**AMENDMENTS TO THE DRAWINGS**

**REMARKS**

FIG.6

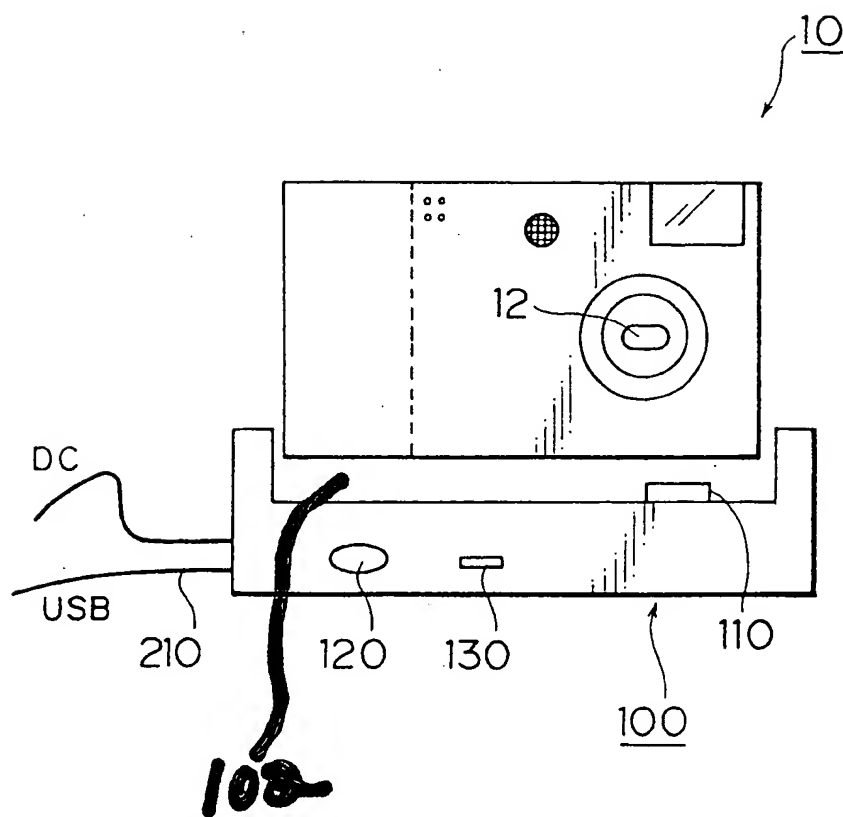
Attached hereto is a proposed drawing change proposing to amend Figures 6 and 7. Regarding Figure 6, Applicant proposes to include element 102 to enhance consistency with the specification. *See, e.g., page 5, lines 5-7.* Regarding Figure 7, Applicant proposes to change the element number of the CCD 66 to 60 also to enhance consistency with the specification. *See, e.g., page 6, line 1.*
